## ADDENDUM NO. 04

<b>PROJECT:</b>	<b>Auburn Park Full Build-Out Montgomery County, VA Parks and Recreation</b>
<b>GNI Job No.:</b>	<b>2893.00</b>
<b>DATE:</b>	<b>Friday, March 15, 2024</b>

PROJECT TEAM	
PIC	TREVOR M. KIMZEY, PE
PM	MATTHEW P. TOMLINSON, PE
DESIGN	NAK, MKF
ISSUE DATE	
01/29/2024	
FDS JOB NO.	
ZMM 2023006	
SHEET TITLE	
PLUMBING PLAN - PAVILION / RESTROOM BUILDING	
SHEET NUMBER	
P121R1

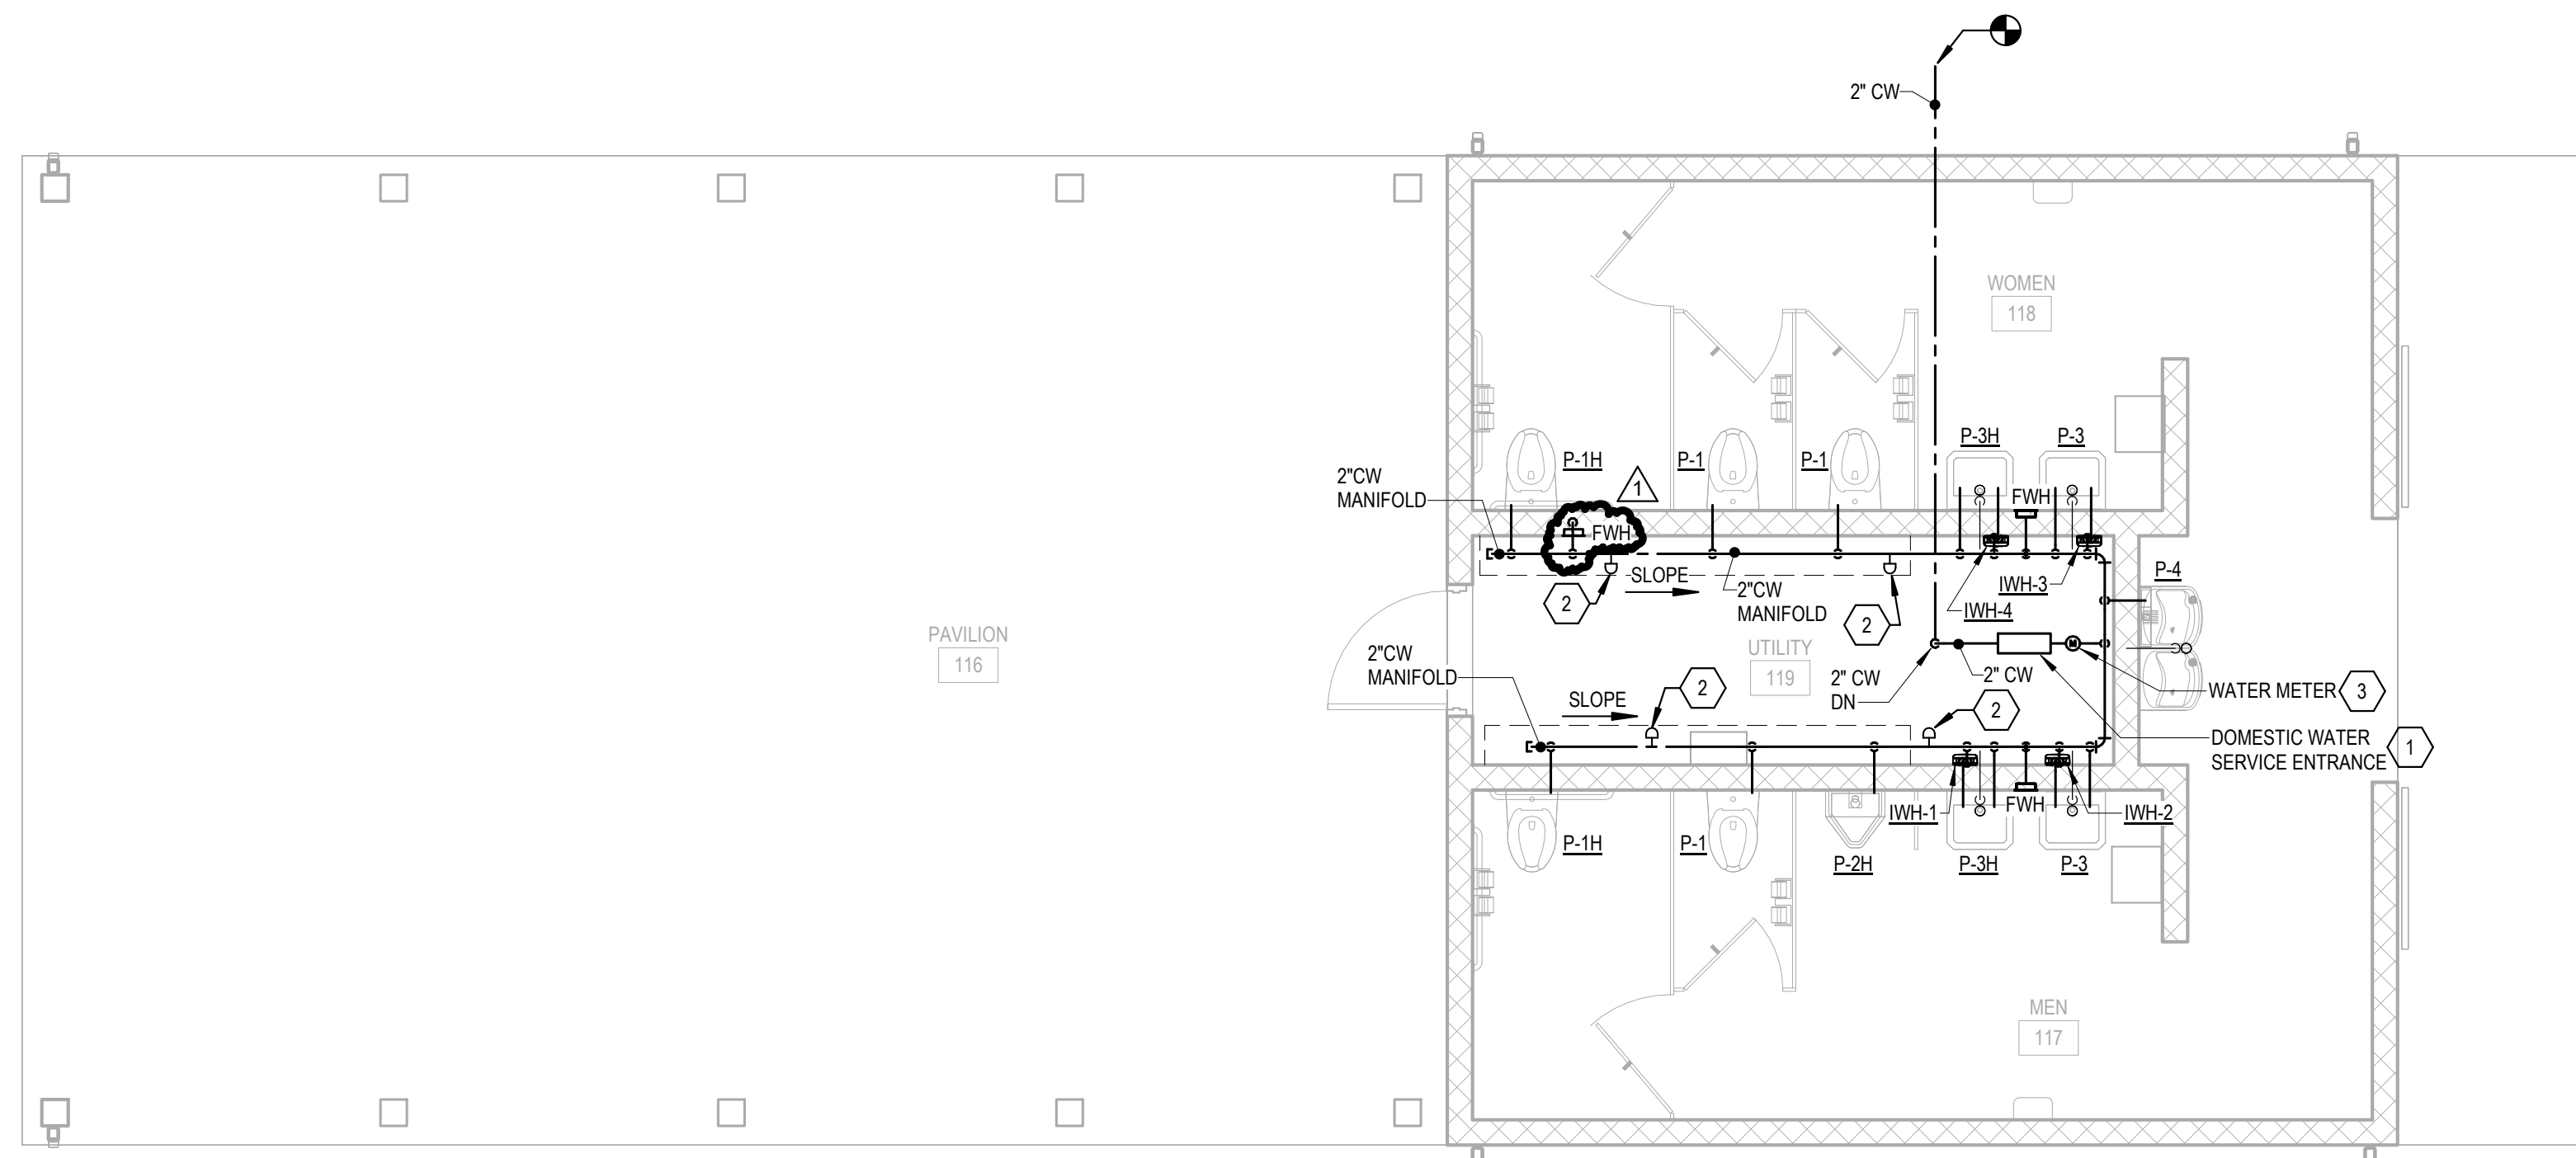
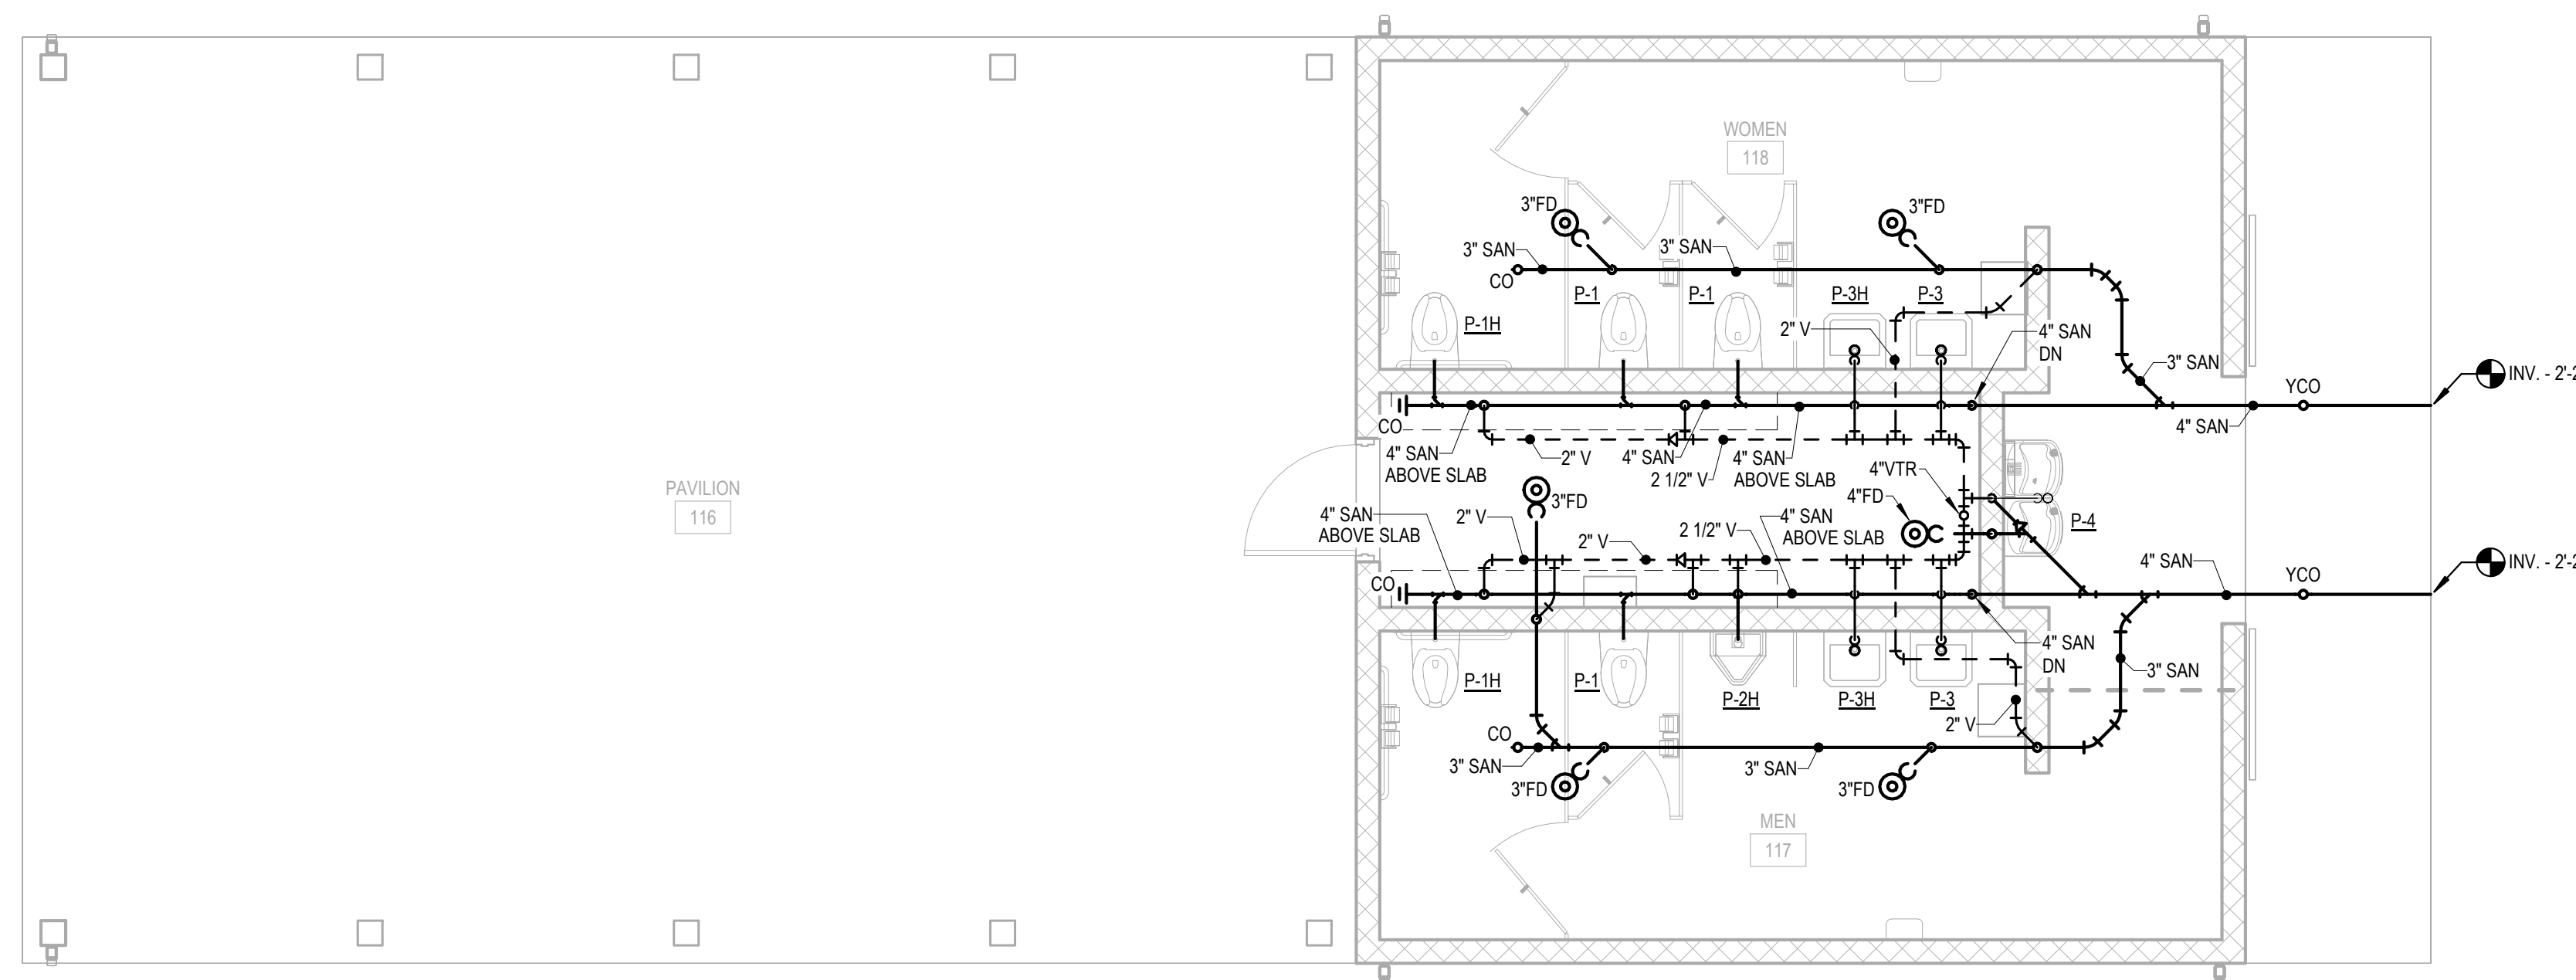
**REVISE** location of FWH freeze proof wall hydrant inside chase as shown in attached revised Sheet P121 with revision date 03/15/24.
